LOCAL TRAFFIC COMMITTEE MEETING

Venue	Conference Room, Station Street, Mullumbimby
Date	Tuesday, 17 August 2021
Time	10.30am
Committee Members	Ian Shanahan – Transport for NSW Detective Chief Inspector Matt Kehoe – Police Cr Basil Cameron Tamara Smith MP

BYRON SHIRE COUNCIL
LOCAL TRAFFIC COMMITTEE MEETING

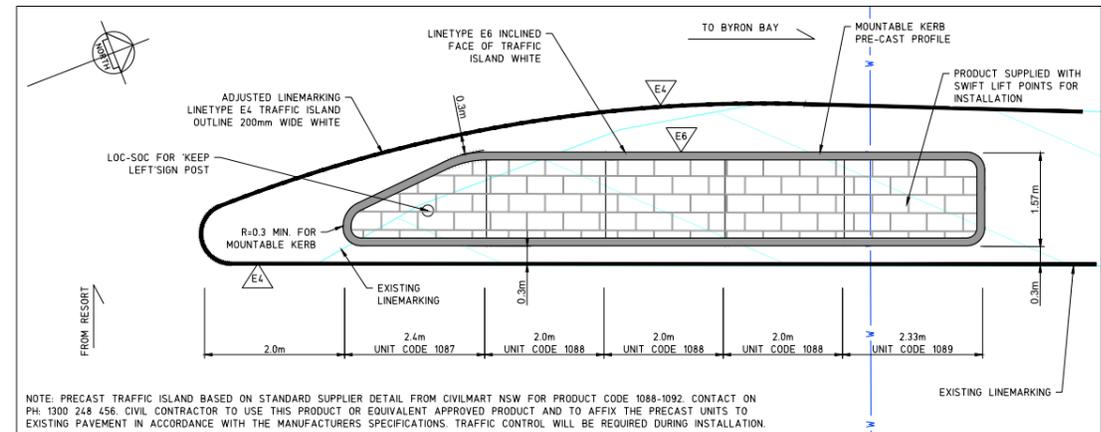
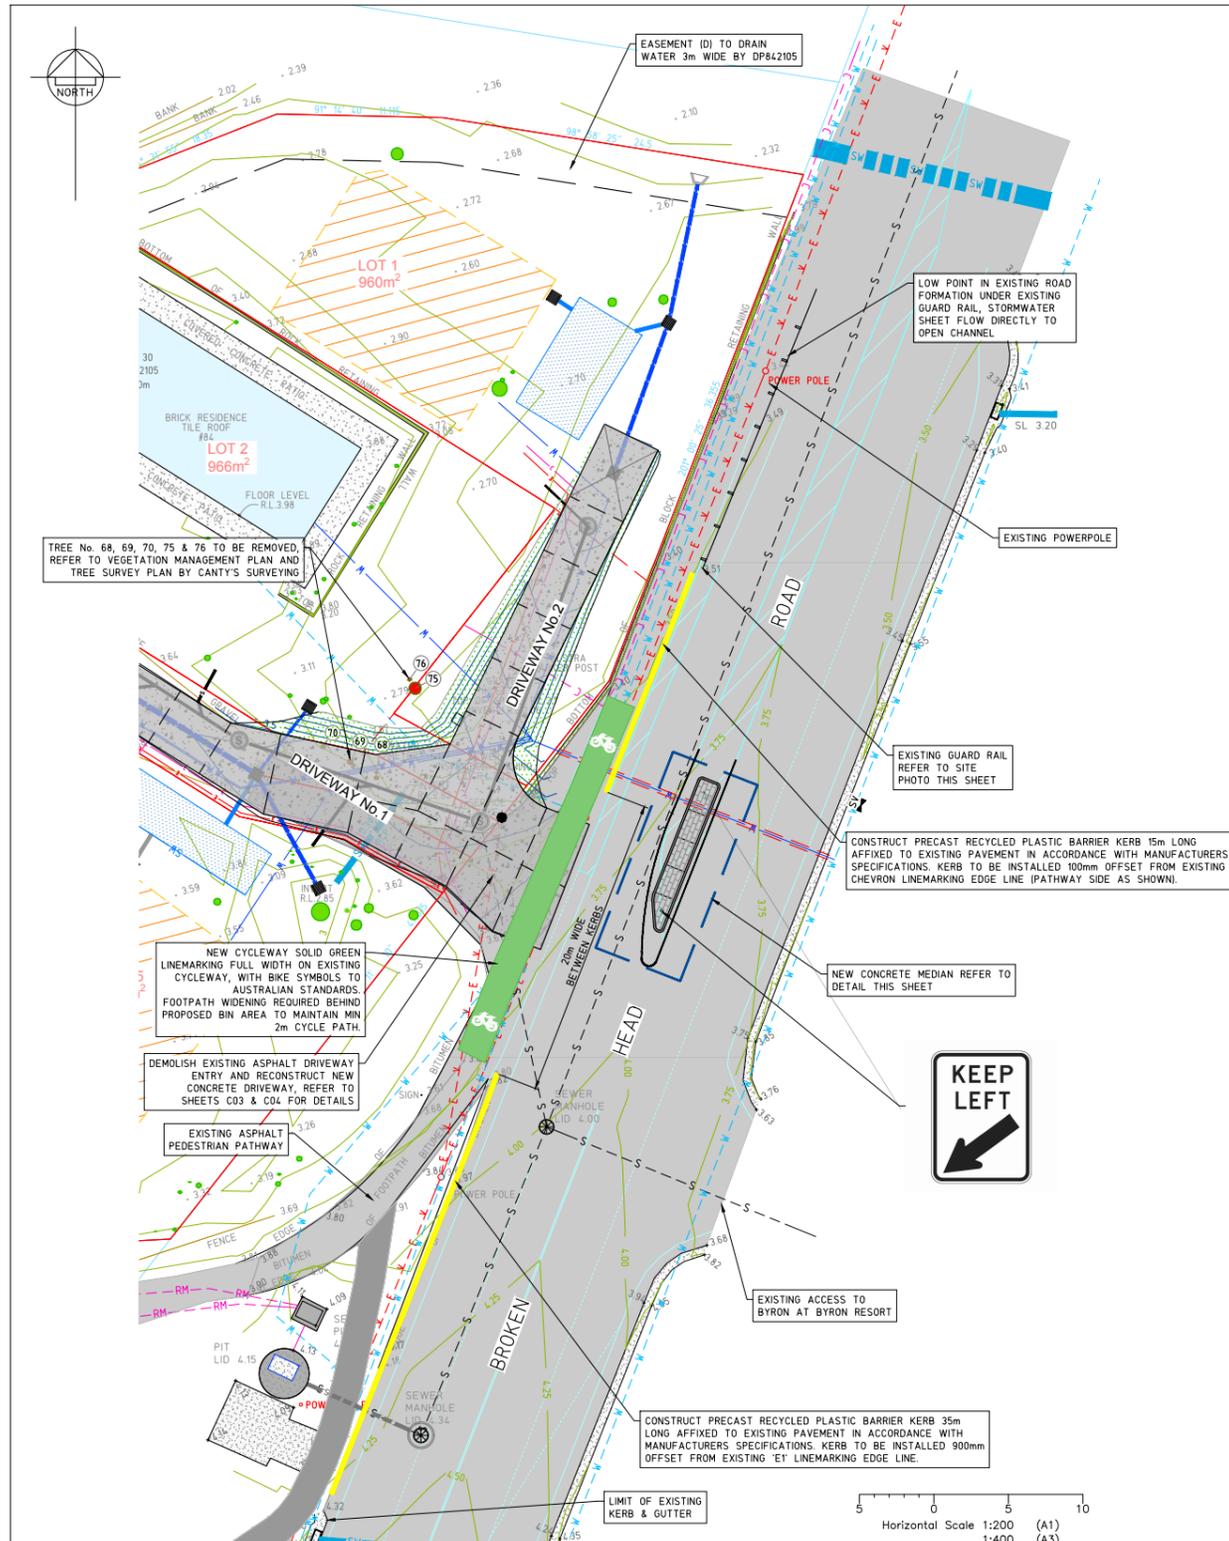
- Should the proposed works vary in any way you must advise TfNSW.
- All works are to be located, designed and constructed in accordance with the Austroads Guidelines, Australian Standards and Roads and Maritime Supplements. The details of the proposed median are not provided in the supplied cross section or plans. The proposed median will need to comply with AS1742.10 with a minimum nose radius and offset to linemarking to allow for Raised Reflective Pavement Markers.

- Any regulatory signs or devices will require the endorsement of the Local Traffic Committee prior to Council approval. Please refer to [A guide to the delegation to councils for the regulation of traffic](#).

- 30 **That Council approve the regulatory devices, signage and line marking shown in Attachment 1 (E2021/97196) which is associated with development application 10.2019.429.1 and Roads Act application 51.2019.429.1.**

Original approved location

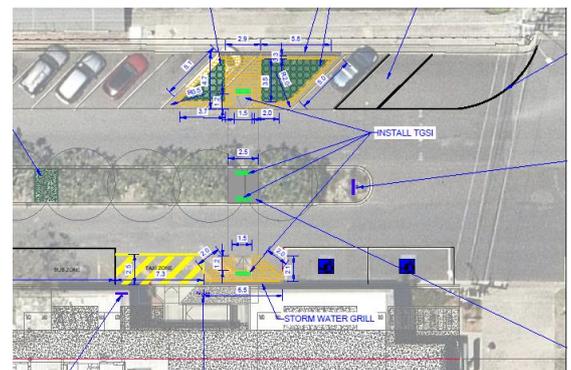
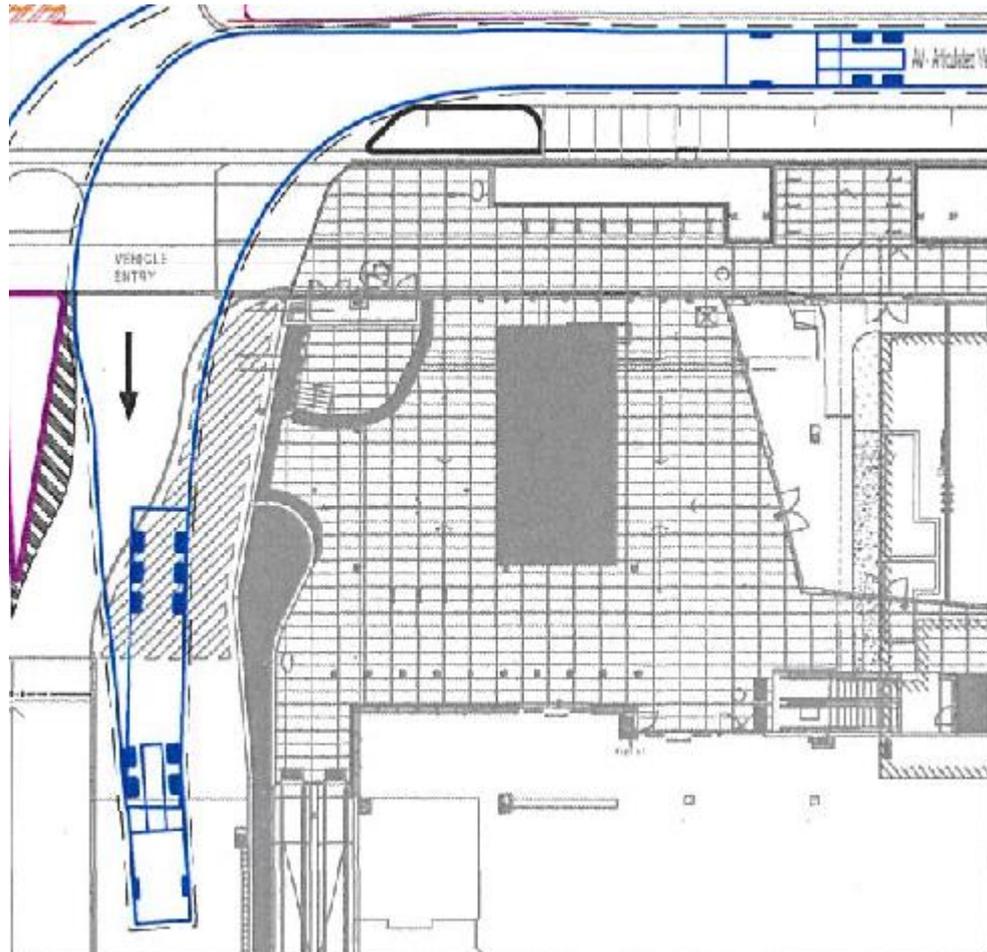
5 This is situated near the development access (see above). This location will reduce the angle parking supply by a maximum of 3 parking spaces on the east side of Jonson St and no reduction of parking spaces west of Jonson St. A net parking supply reduction of three (3).

This location is close to Mercato building's main entrance providing the shortest distance for pedestrians (approximately 5m) to gain entry and exit of the development and currently being used by the majority of pedestrian crossing in the Jonson St.

10 The proposal offers more details than the approved location however the proposal will provide a greater impact to the supply of the existing taxi ranks adjacent the development and parking.

The comparison based on the criteria above found that the originally approved location in DA10.2013.587.1 will provide a more suitable location than the new proposal.

DRAWING TITLE
**FUNCTIONAL LAYOUT
PROPOSED ACCESS ARRANGEMENT**

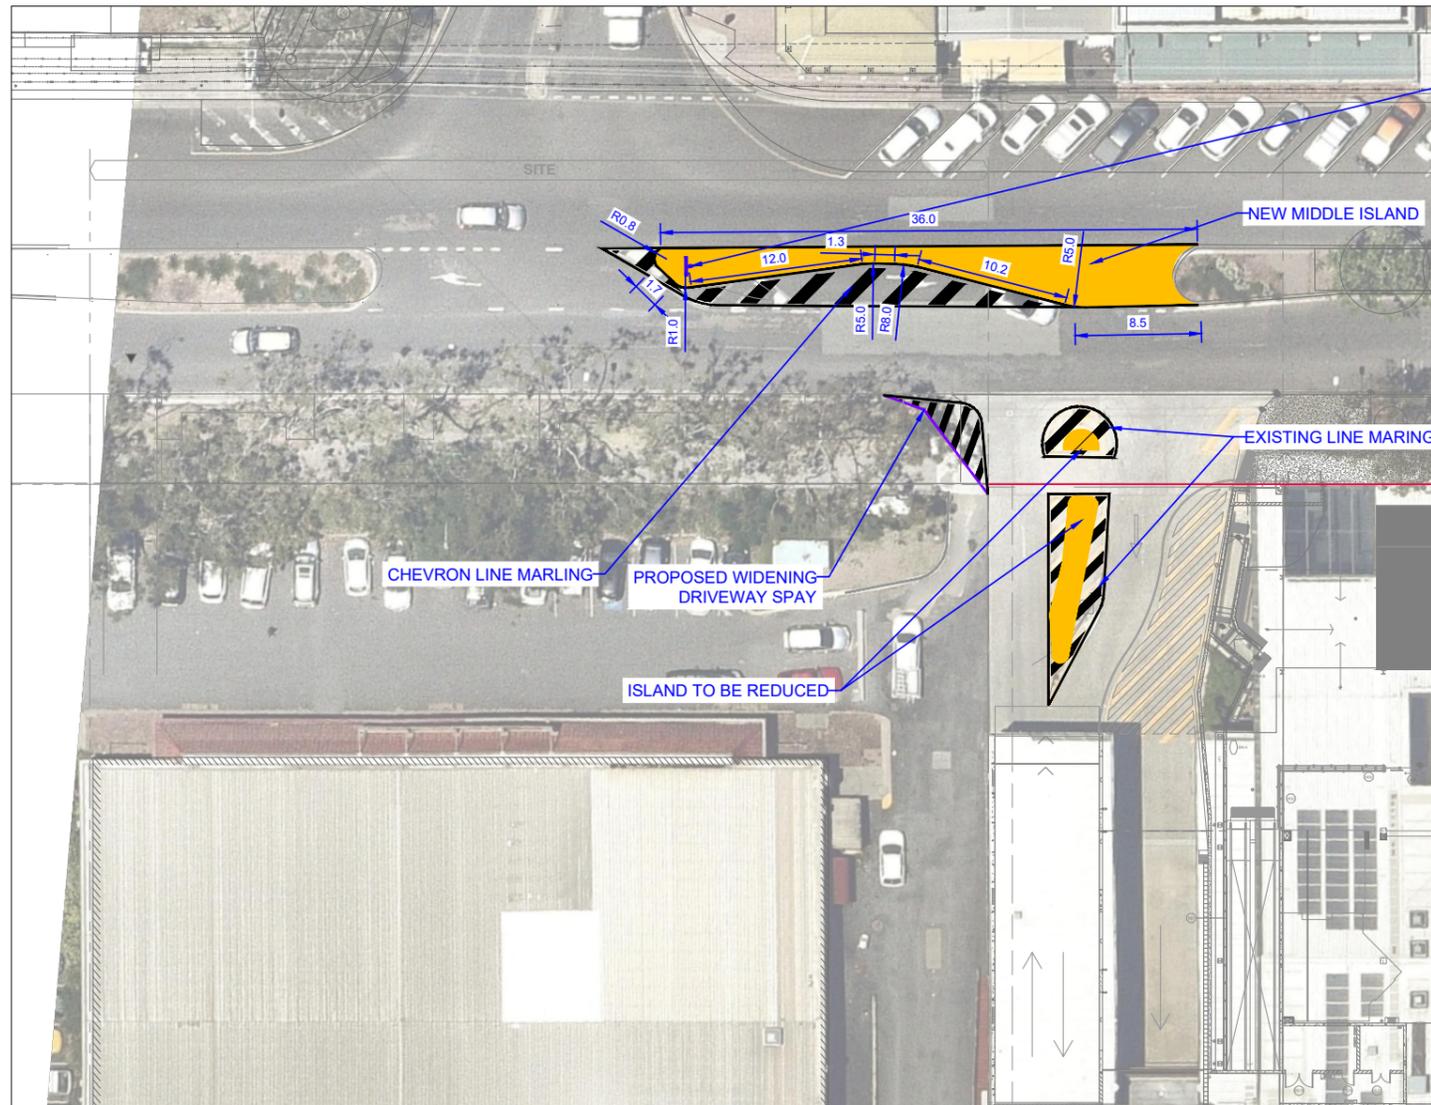
TfNSW supports the provision of pedestrian and taxi facilities. Consideration needs to be given to the location of the proposed crossing with respect to sight distances to nearby intersection, property access, on-street parking and landscaping. The proposed arrangements include regulatory facilities requiring advice and/or approval from Local Traffic Committee (LTC) prior to Council approval. It is recommended Council obtain comment from LTC.
